QUALITY ASSURANCE -- NON-CONFORMANCE REPORT

Report No: NCR-000480

Reference Description: Distortion of an upper flange of Floor Beam member at PP43 after weld repair

Job Name: SAS Superstructure

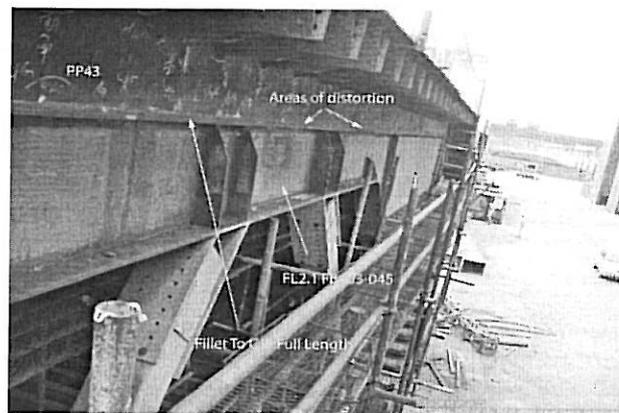
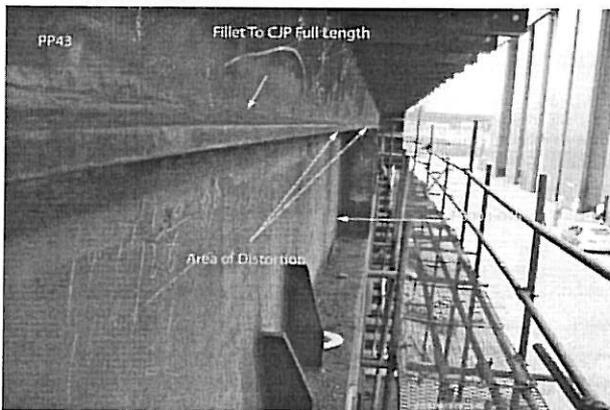
During random visual inspection of OBG Segment 6BW at panel point 43, Caltrans Quality Assurance (QA) Inspector observed that the FL2-1 Floor Beam designated as FB003-045 was distorted on the upper flange plate X6F after the weld repair at the adjacent weld joint. The adjacent deck panel diaphragm weld that connects to this upper flange plate was changed from a fillet weld to a complete joint penetration (CJP) weld due to fit up issues. The maximum distortion at this upper flange X6F measured 12mm.

简图 Sketch

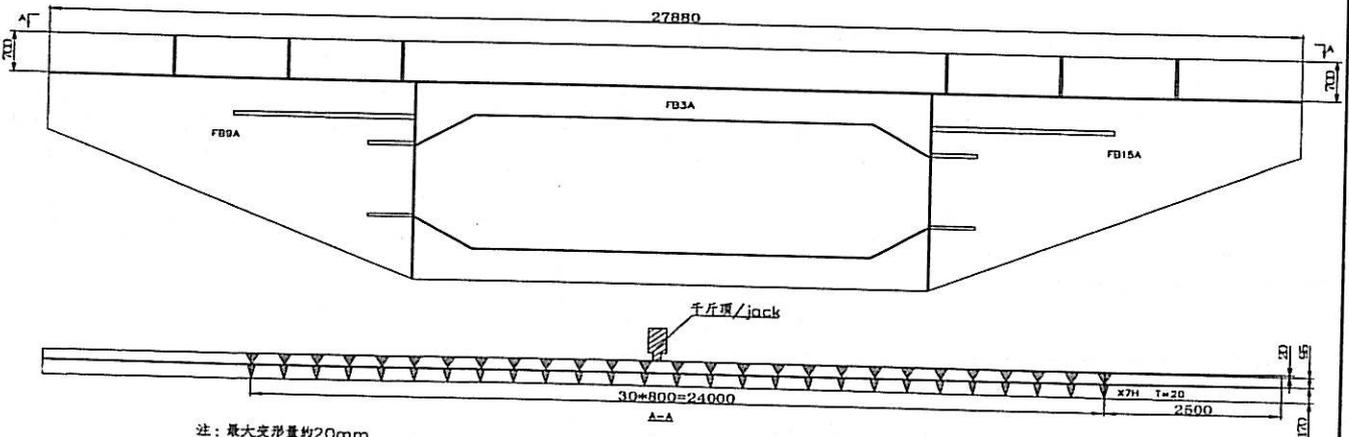
注: 最大变形量约20mm
NOTE: the max deformation is about 20mm

After finishing heat straightening, the weld of the heat area shall perform NDT according to the approved shop drawing 校火后, 根据图纸要求对热影响区域进行 NDT 检测。

Control current, voltage and weld speed according to relevant WPS. If necessary anti-deformation or hold down device can be added. 依据相应的 WPS 的要求控制电流, 电压和焊接速度。如有必要, 可使用反变形设施进行校正。
